Purchasing Division
18 North County Street – 9th Floor
Waukegan, Illinois 60085-4355
Phone 847 377-2929
Fax 847 984-5889

ADDENDUM #2
REQUEST FOR PROPOSAL #13231
COUNTYWIDE RADIO COMMUNICATIONS SYSTEM
RFP Opening Date: OCTOBER 31, 2013, 2:00 p.m. local time

Please note the following clarifications, revisions, and/or additions to the RFP documents.

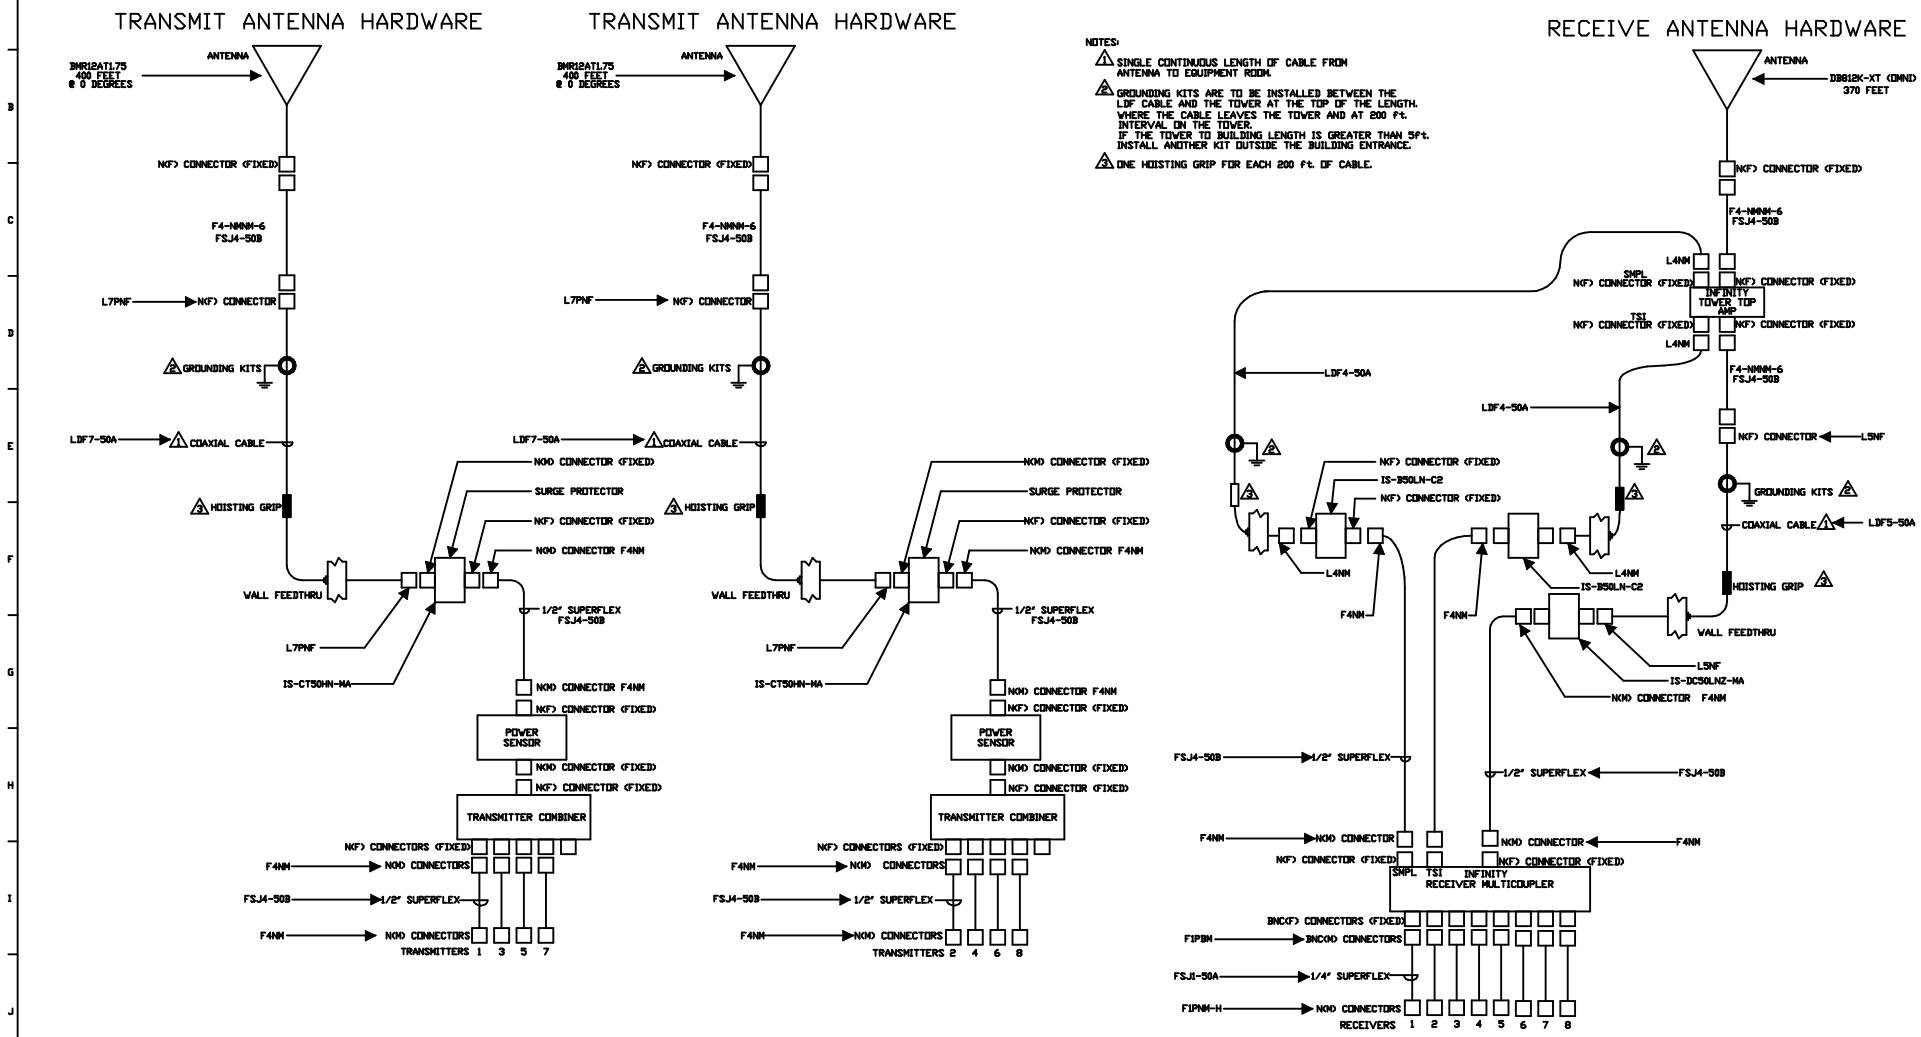
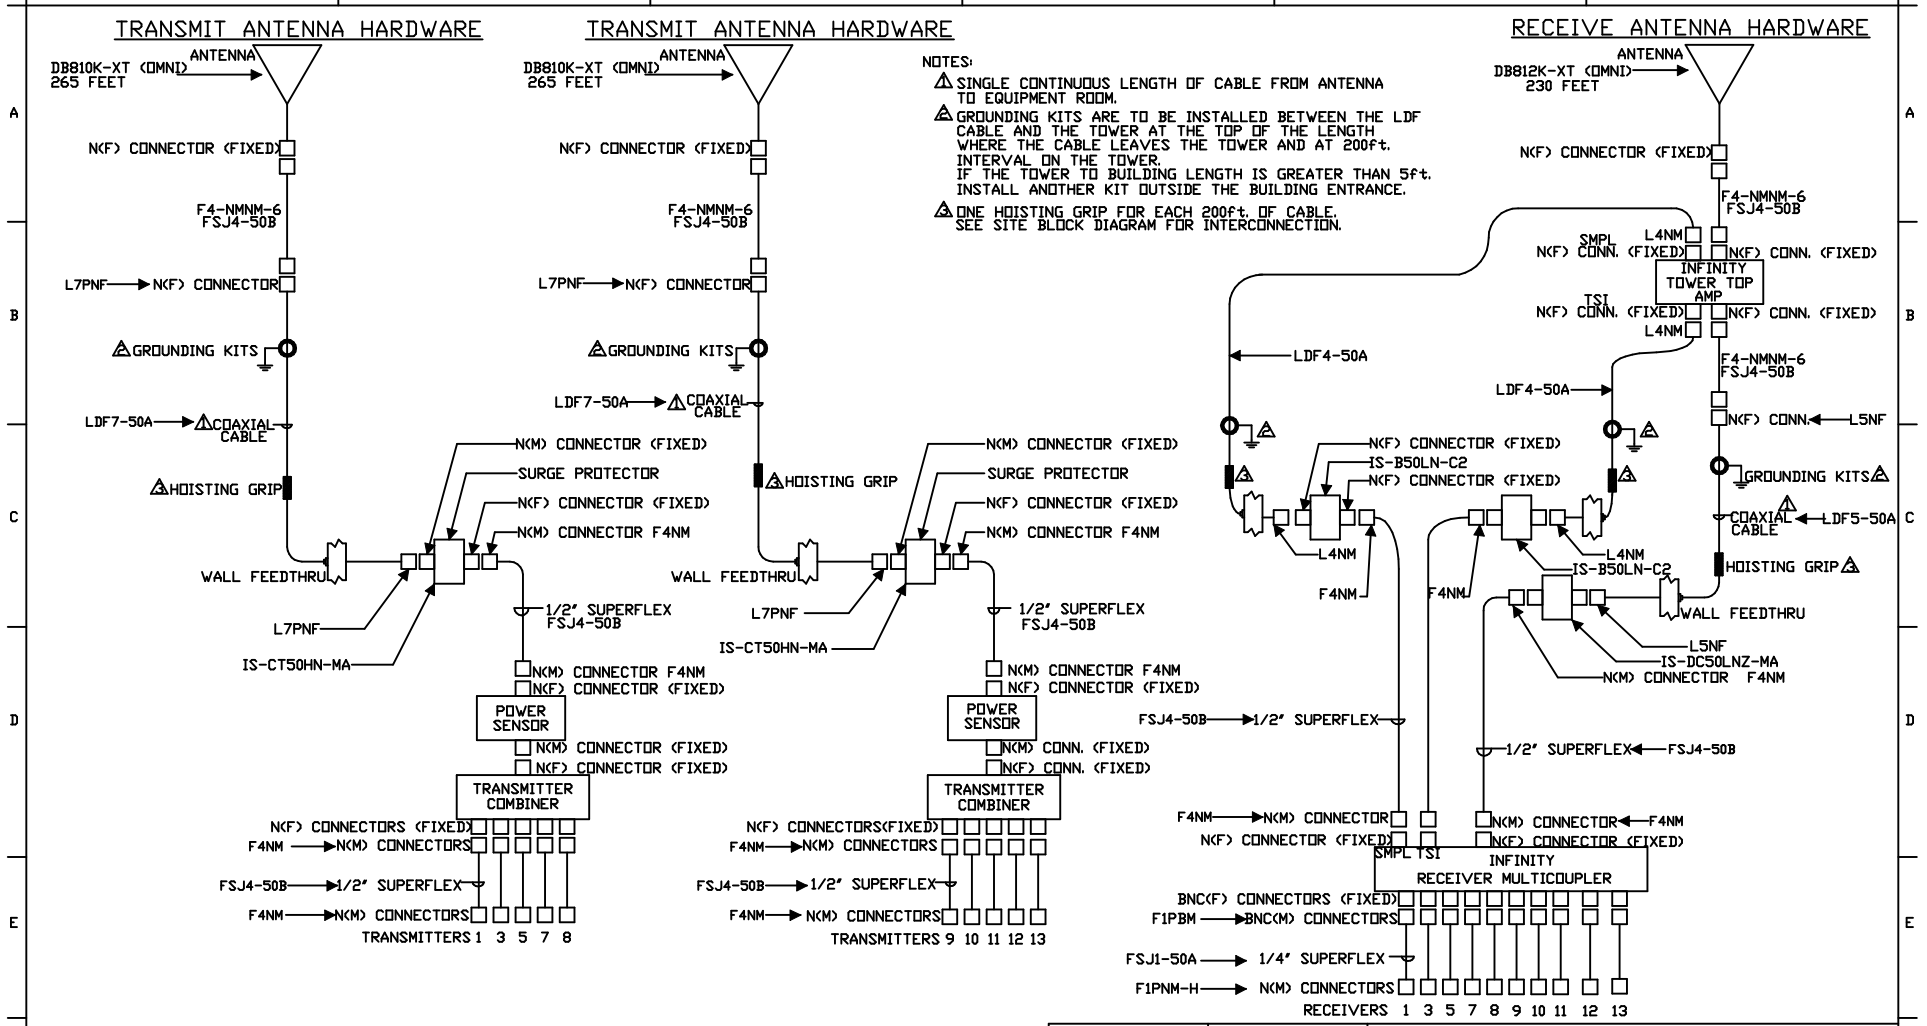
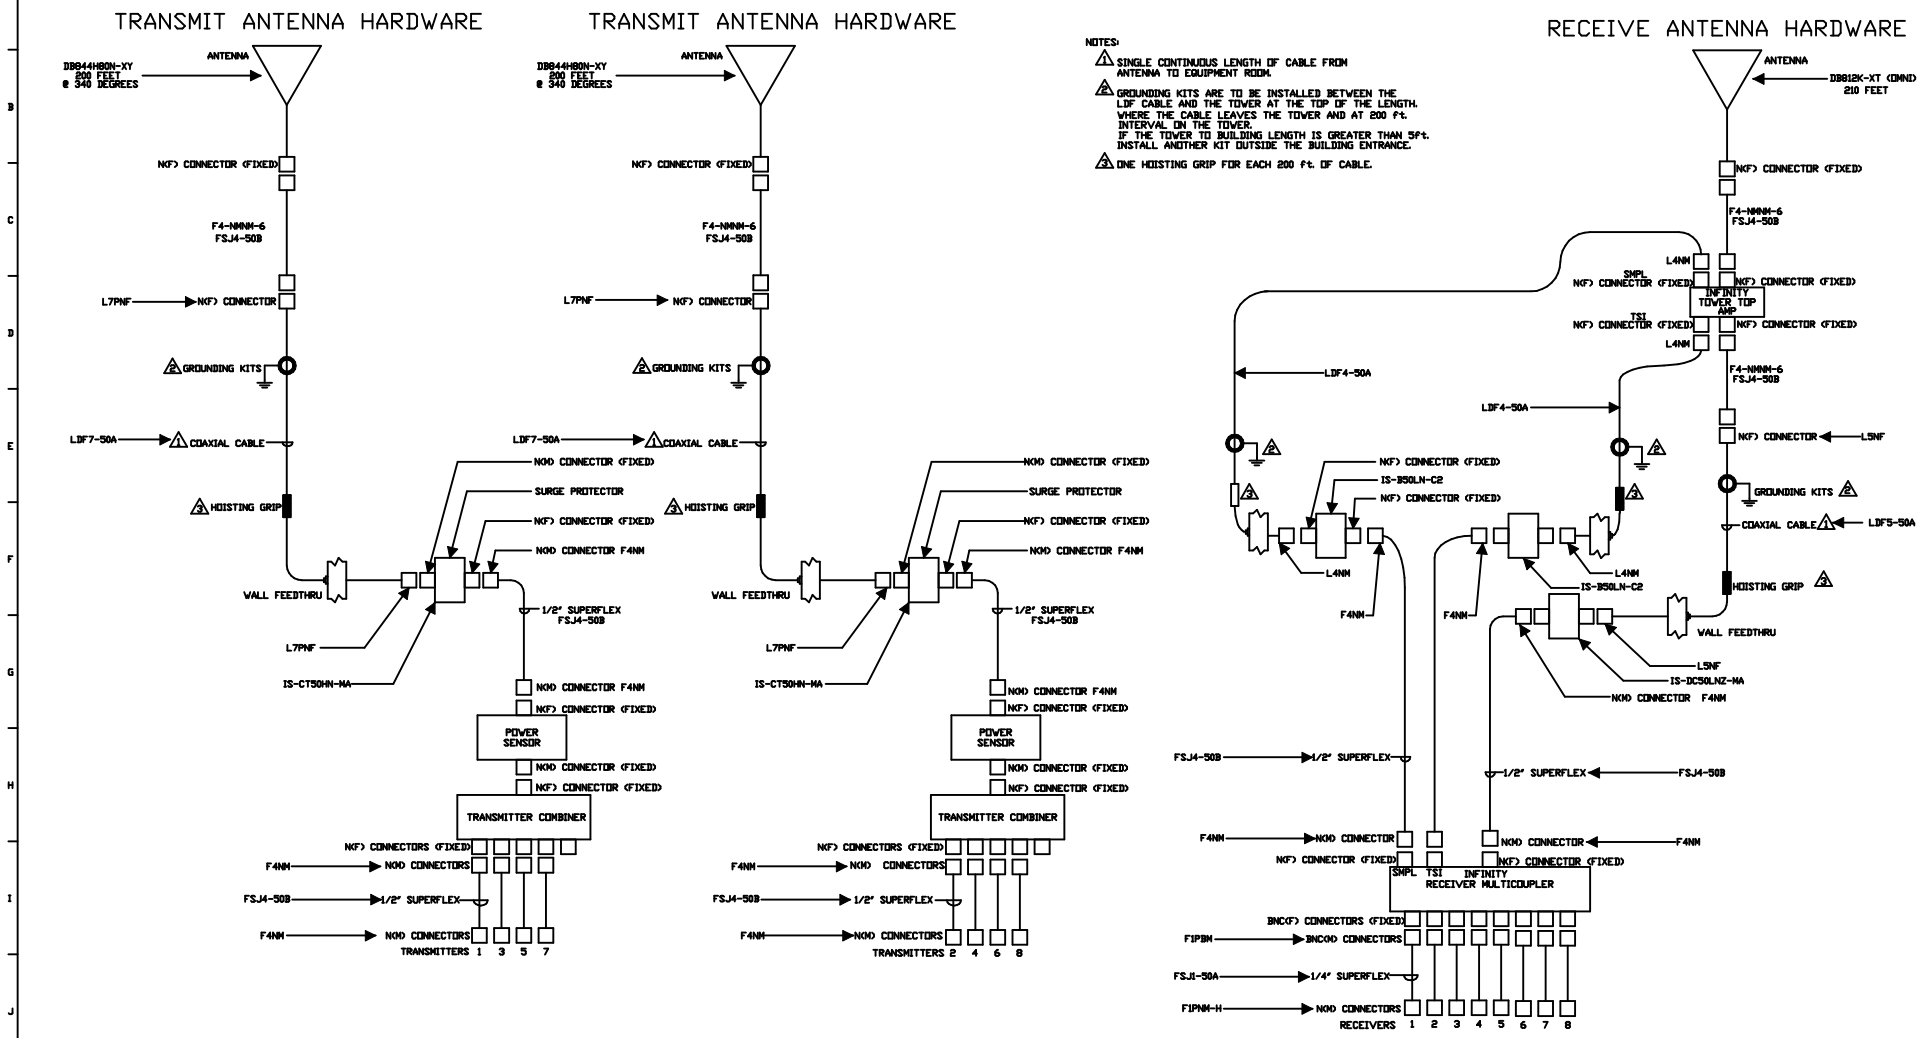
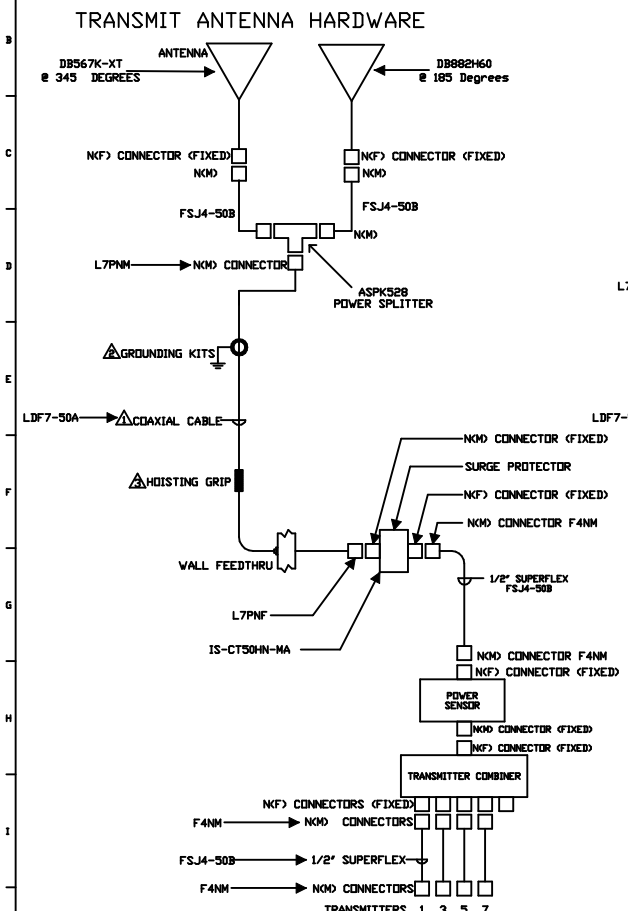
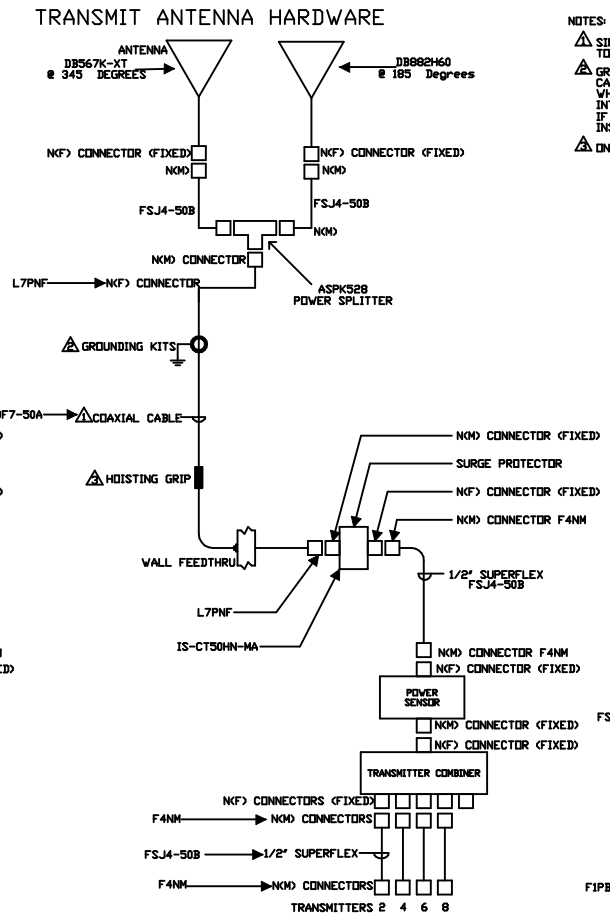
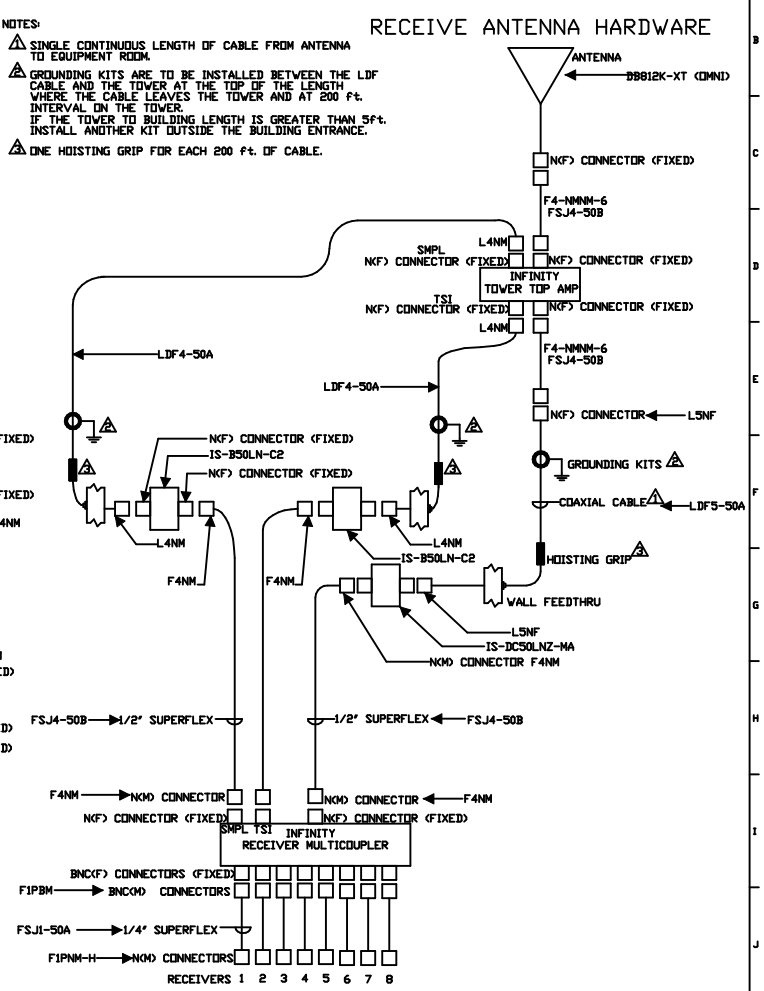
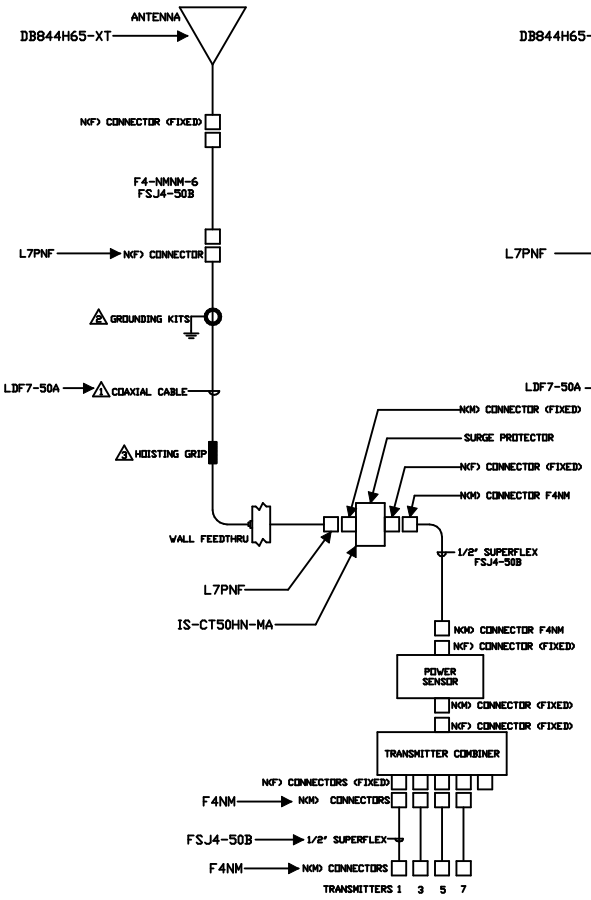
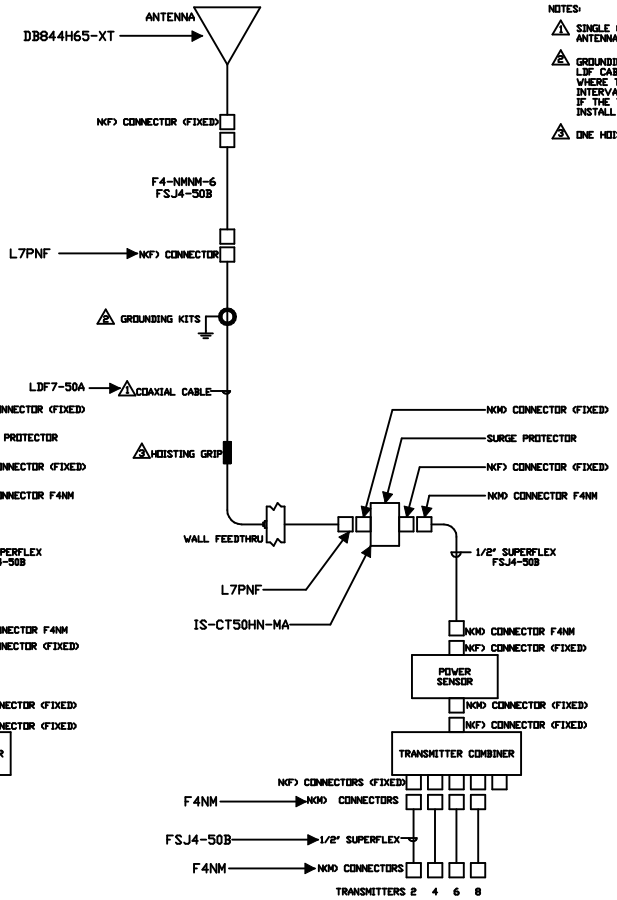
Question: Please provide information on Existing Site Antenna Heights for the RF sites.
Response: Attached are the original drawings indicating the antenna assembly at the time of system implementation.
